COMMITTEE REPORT

6 April, 2016
06
15/5130

LOCATION: 1 Craven Park, London

PROPOSAL: Erection of a six storey building comprising 21 self-contained flats (9 x 1bed, 9 x 2bed and 3 x 3bed) with associated cycle storage, bin stores, communal and private amenity space and landscaping

Site Layout Plan

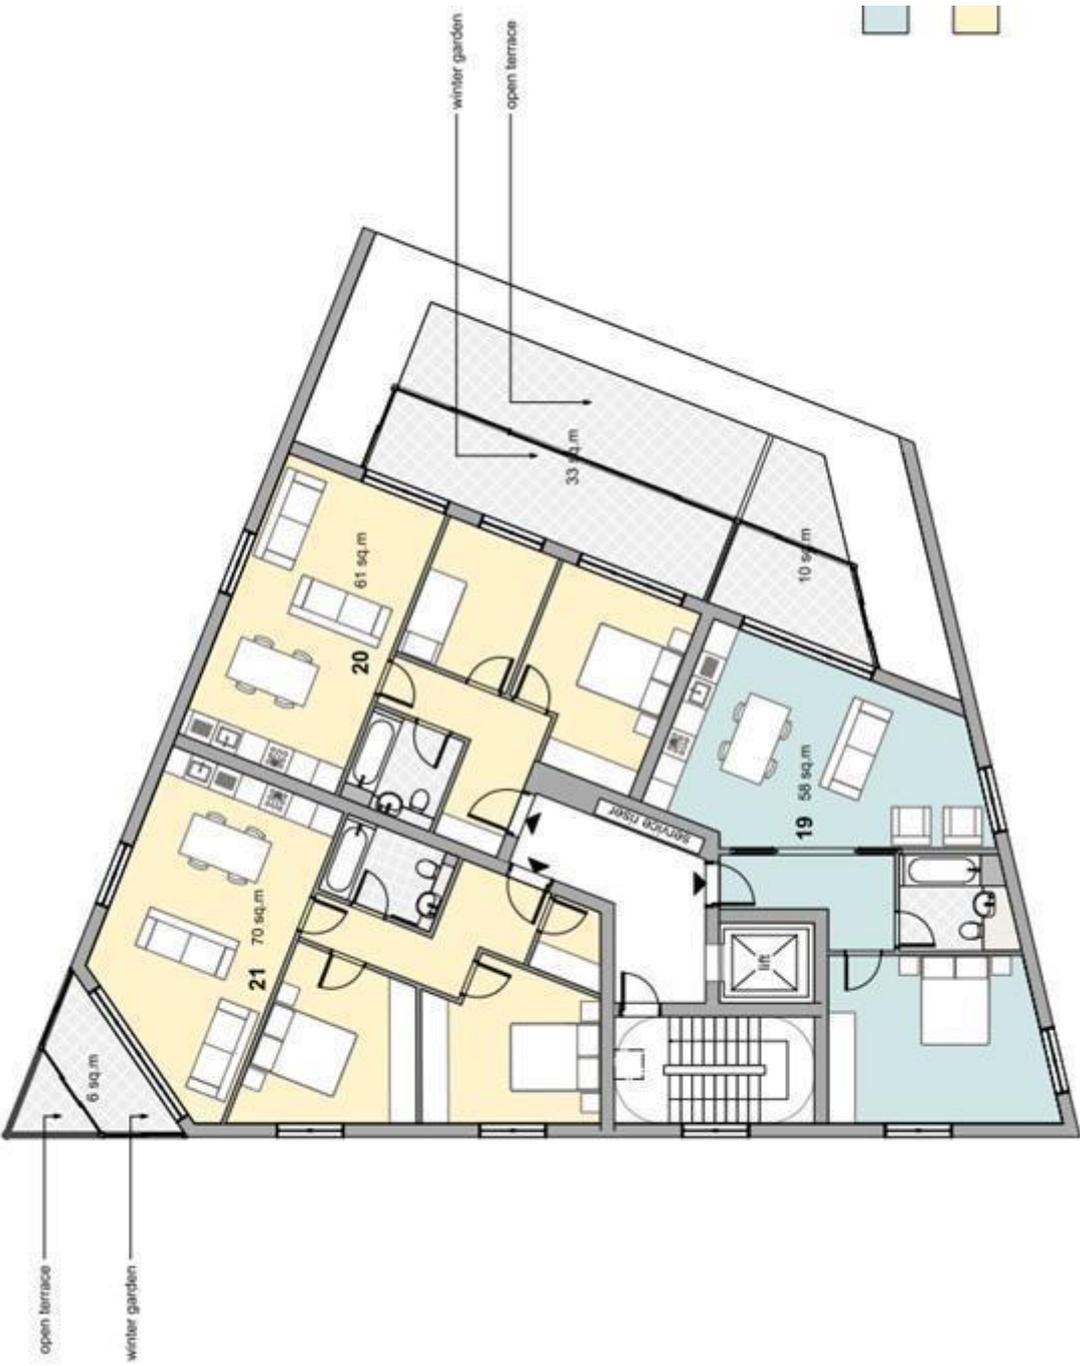
The layby proposed on the northwest side of the site would provide space for 2 disabled parking bays if they were required by residents of the development. While the proposed location of the bay is acceptable though it would need a width of 2.7m to provide sufficient space for safe use by disabled drivers on this busy gyratory system. The pavement would also need to be at least 2.5m wide. It would be required that the footway be constructed by the applicant and adopted by the highways authority.

Four Eurobins would be required for the number and size of flats proposed meaning the store would need to be enlarged and is currently undersized. Doors to all stores need to open inwards, not over the public highway, which would require a further enlargement.

The elevation drawings include soft landscaping externally around the perimeter of the site which appears to screen the boundary treatment. The ground floor plan also shows the introduction of trees around the site providing landscape value and privacy. There are also existing trees, both in and outside of the site, which would require full protection details were a development to go ahead on the site.

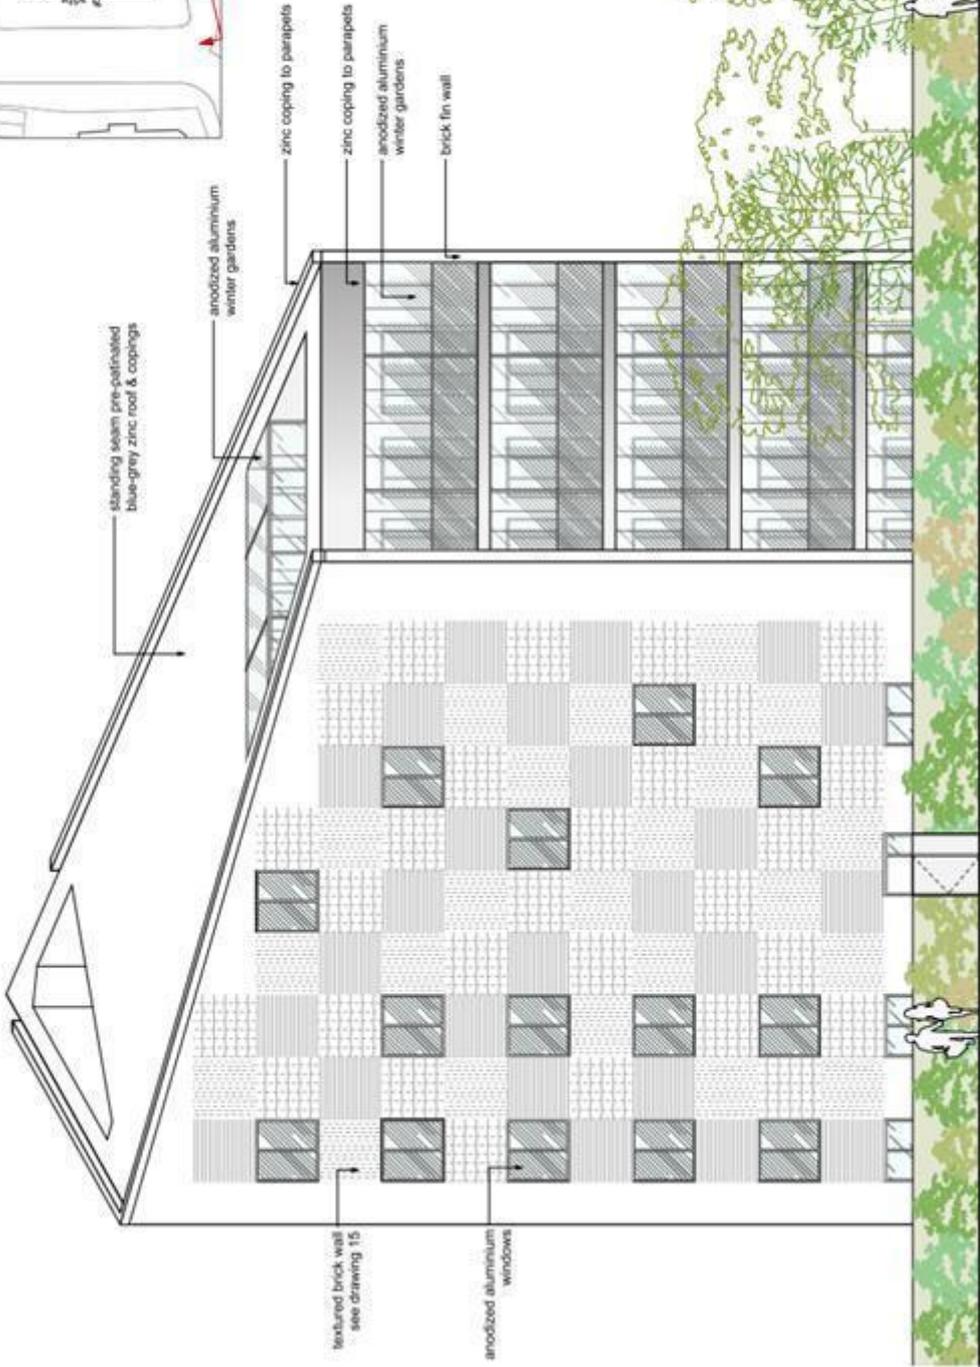
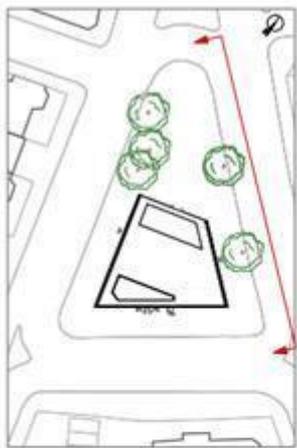
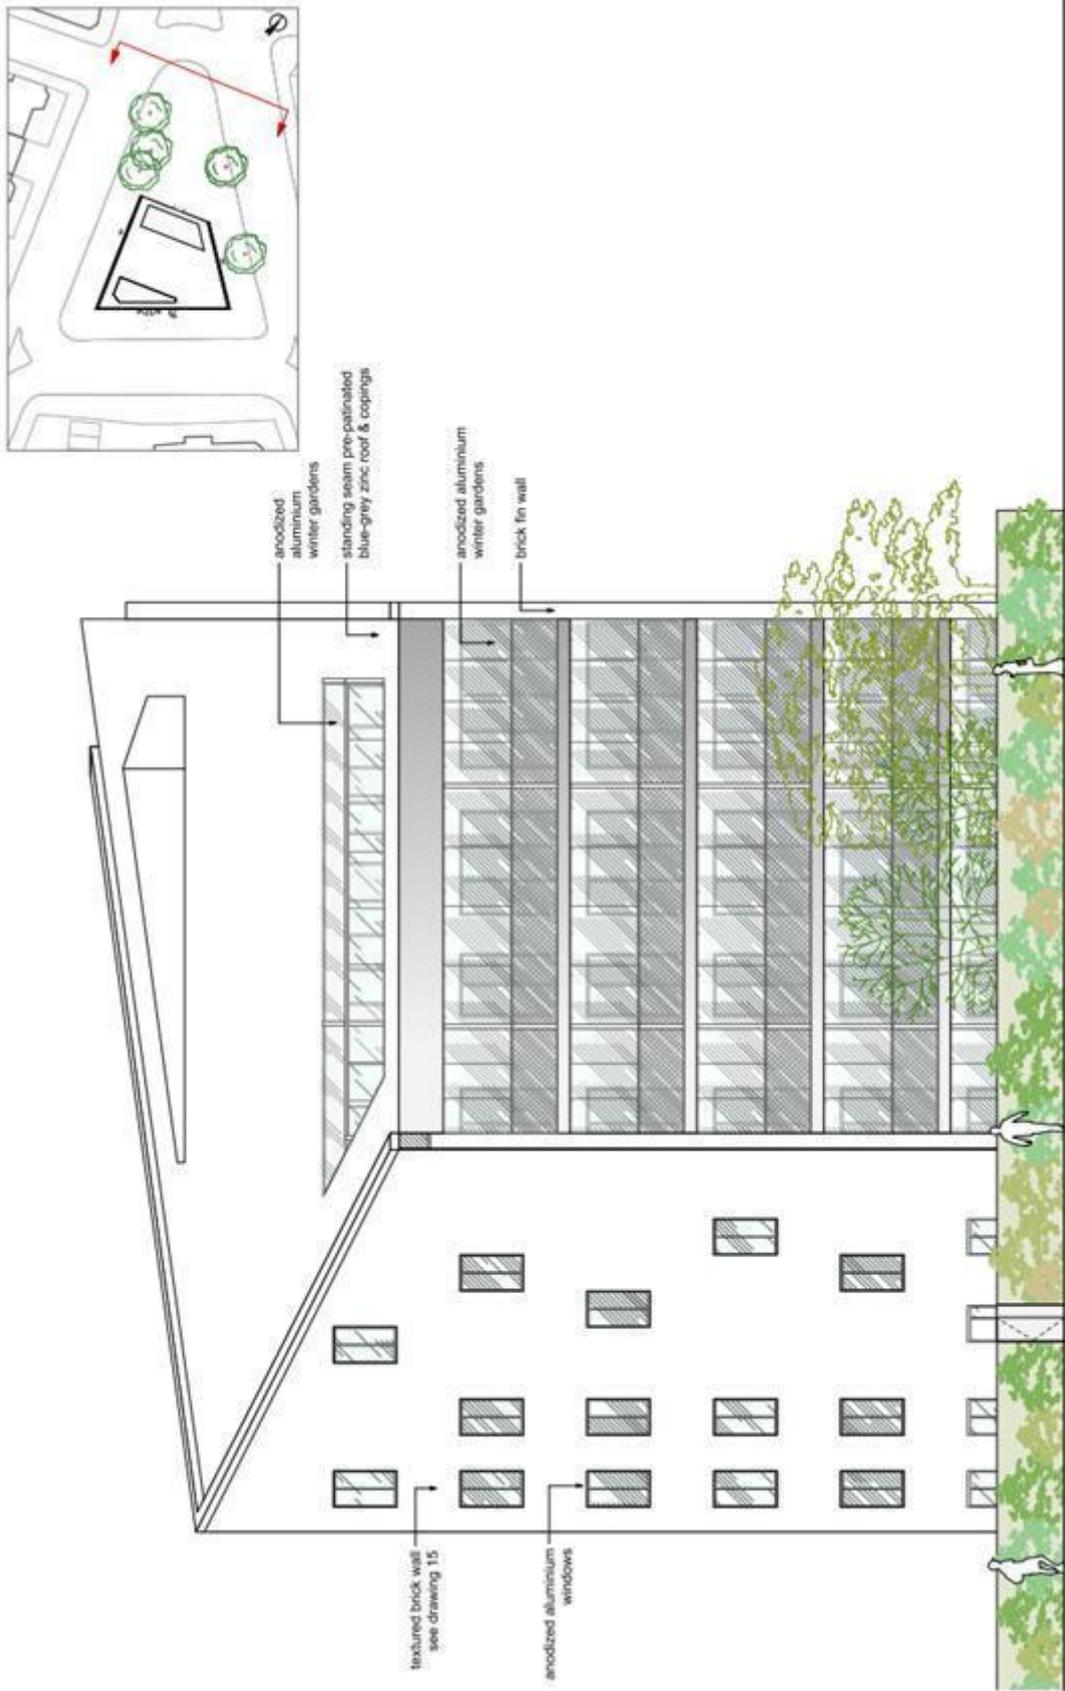
The character of Craven Park leading to the site is of two-storey houses with front gardens while High Street consists of three-storey terrace properties. Whilst officers are not of the opinion that the height needs to be limited to the neighbouring character the forum remains of the opinion that 6 storeys exceeds what the site is capable of accommodating. The scale and bulk of the proposed building would result in an overbearing impact on the street scene.

The sloped roof adds some interest to the large building design however it also has the result of effectively adding the height of a seventh storey at the north-western end. The high density of the scheme reinforces the view that the scale of the development proposed is too great. A maximum height of 5 storeys was previously suggested subject to the quality of design.

The elevations are proposed to be detailed with patterned brickwork which is considered to be an acceptable approach in principle however may be more successful for a smaller building and the height and massing of the building remains unacceptable. The proposed windows appear relatively small within the expansive elevations and balconies are restricted to one corner and one elevation so do not provide relief throughout the elevations.
